# WisDOT Bridge Manual

## January 2024 Updates

James Luebke, P.E.  
Policy and Standards Engineer  
February 21, 2024

- Std. 30.02
  - Added dimension note for C8x11.5 member

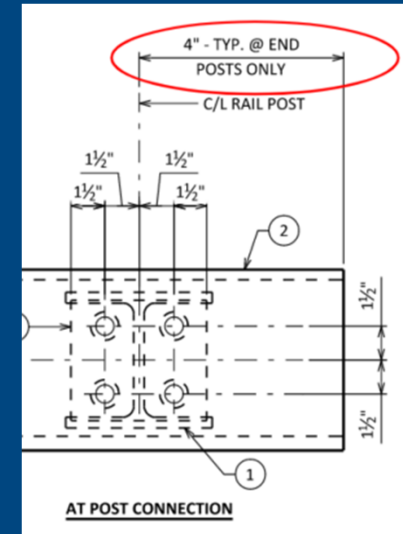
② C8x11.5 WITH  $1\frac{3}{16}$ " DIA. HOLES FOR NO. 8.
